**REVISED RESPONSE TO REQUEST FOR ADDITIONAL INFORMATION****APR1400 Design Certification****Korea Electric Power Corporation / Korea Hydro & Nuclear Power Co., LTD****Docket No. 52-046**

**RAI No.:** 347-8435

**SRP Section:** 15.04.03 – Control Rod Misoperation (System Malfunction or Operator Error)

**Question No. 15.04.03-1****REQUIREMENTS AND GUIDANCE**

Figure 1. Time vs. Core Average Heat Flux (12-Finger CEA Drop)

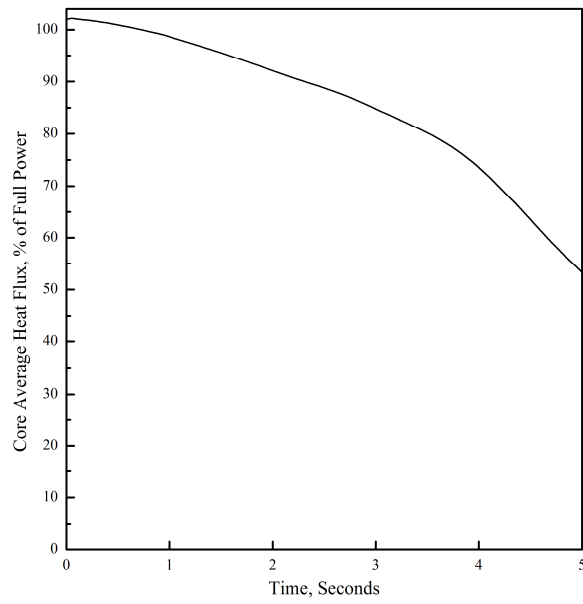
In addition, the audited calculation note indicates that, as of August 2012, the 12-finger CEA drop had not been evaluated but will be in future analyses for the core operating limiting supervisory system (COLSS) and the core protection calculator system (CPCS). The calculation note also states that, if a 12-finger CEA drops, the CPCS will appropriately generate a trip if it is necessary because the CPCS conservatively calculates DNBR every 0.05 seconds. The applicant has nevertheless provided no information on its analyses for 12-finger CEA drop events. Absent such information, the staff can neither assess the applicant's analyses for a range of 12-finger CEA drop events nor verify their implications, if any, for determining the limiting CEA drop event.

Please provide justification that the four-finger single CEA drop is the limiting event for DCD Section 15.4.3. A summary of analysis results using different rodded core configurations, dropped rod types and locations, and different cycle conditions would assist the reviewer in confirming that the event analyzed is the limiting event. Supporting information should include the basis for the maximum radial peak distortion factor of 1.205 as well as a summary of analyses performed for 12-finger CEA drop events.

Figure 1 and Figure 2 show the typical heat flux and DNBR behavior during the 12-finger CEA drop event. In this analysis, the 12-finger CEA drop occurs at 0 seconds and CPC generate reactor trip signal at 0.85 seconds including the processing delay time and reactor trip breaker opening time. And considering the holding coil decay time (0.5 seconds), scram rods begin to drop into the core at 1.35 seconds. Although the DNBR is decreased due to the static Fr distortion within 1 second, the DNBR begins to increase in combination with heat flux decrease by 12-finger CEA drop. After that, the minimum DNBR is maintained above the DNB SAFDL by CPC trip.
